CARILLON POINT, LEVEL 7

PLUMBING
LEVEL 7

IP-207

PERMIT # PLM12-00022
ADDRESS 4100 CARILLON POINT
PLANS FOR AI TERATION - COMMERCIAL
PROJECT CARILLON POINT/7TH FL BREAKRM
OWNER CARILLON PROPERTIES
DATE SUBMITTED 02/17/2012
DATE APPROVED 2/22/12
APPROVED BY

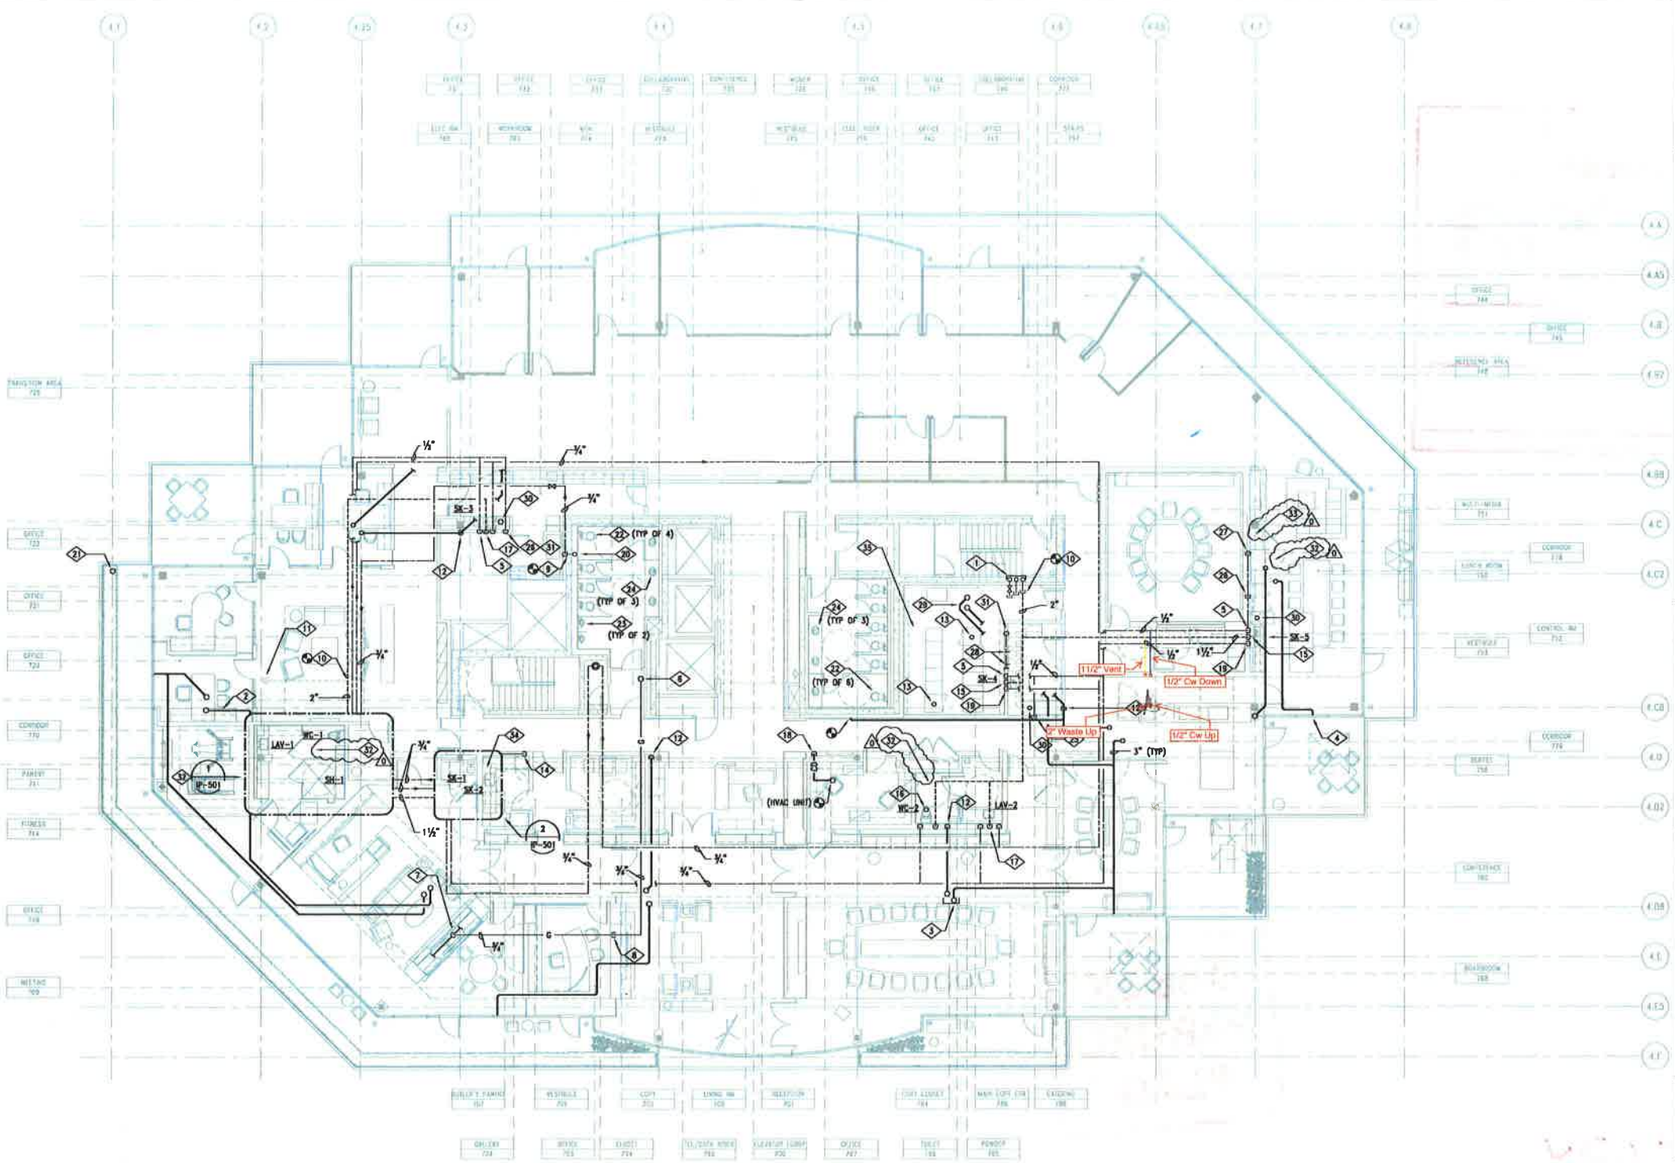
1. Metal Pipe Penetrations Filled w/ Rockwood:4 Hilti FS-ONE
2. No Wet Venting
3. XRAY Prior to CoreDrill
   - to Avoid Post Tension & Other Steel, etc
